From: Mitchell, Harry
Sent: 26 May 2020 14:50
To: Eaves, David
Subject: RE: Former Colt Int. site, Havant - Consultee Responses APP/19/01166

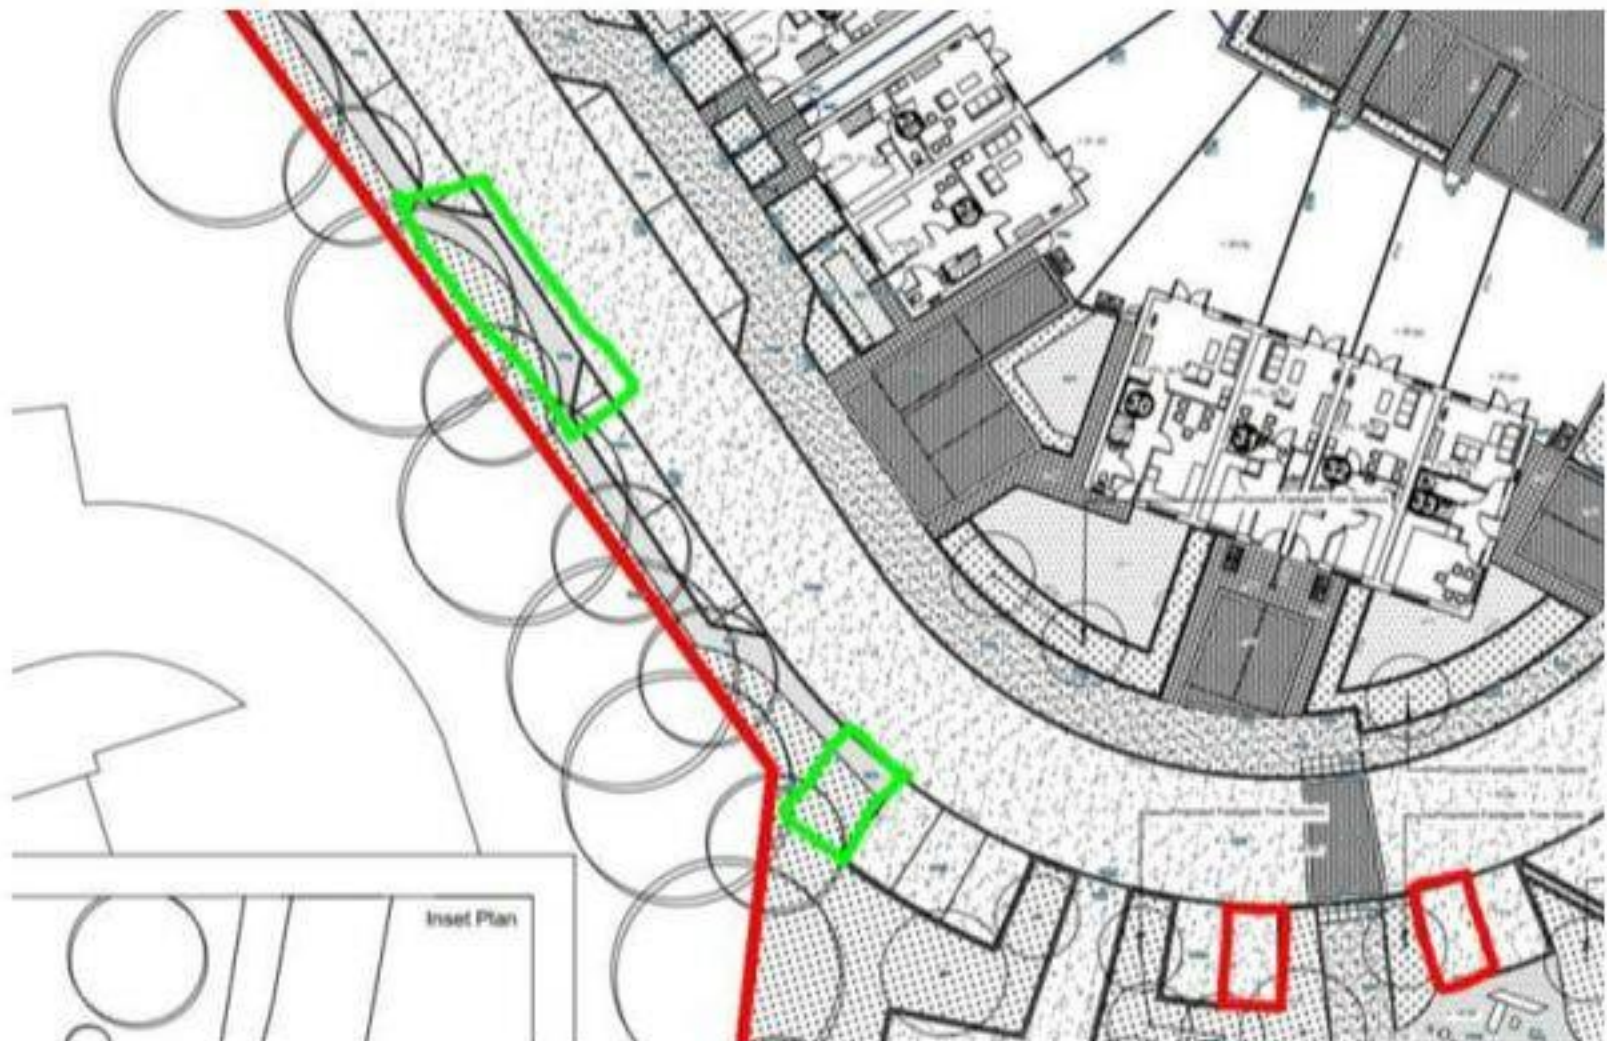
I accept that at this stage getting the location of the POS altered is realistically not achievable. However it is a comment that we have been reiterating throughout the application and it's a shame that the location of the open space has be pushed to the margins, and in my view is to the detriment of its quality.

With regards to the parking to the frontage of the open space I do feel that this is still a problem but it's the same old clash of managing parking requirements and trying to achieve the best quality open space. I had been liaising with Jacqueline regarding *Provision of public open space in new develop policy E9* and the current layout is contrary to the guideline; *5.92 On-site space should generally be provided largely as one principal park providing a focal point for the development. This also means that other elements of the site layout, such as car parking provision, should not create undue physical or visual barriers around the open space. It must also be connected appropriately to all parts of the development by surfaced footpaths.* I must add that this policy is taken from the 2036 local plan, which as far as I am aware is not adopted yet? So whether this would diminish its weight I am not sure.

Just looking at the layout it does seem possible to relocate 2 parking spaces which would go some way to helping with the surveillance of the open space. Perhaps we could put this to the applicant and see if it would be achievable?

I must have missed the agents response in relation to the planting outside plot no. 66 and its effects on the visibility splay. As such we should look for feature low level planting to frame the bell mouth whilst still retaining the proposed tree north of plot no. 58.

Happy with the approach on the lighting. I just wanted to ensure that the access route through the open space was adequately lit and the bollards did not feature on lighting drawing.
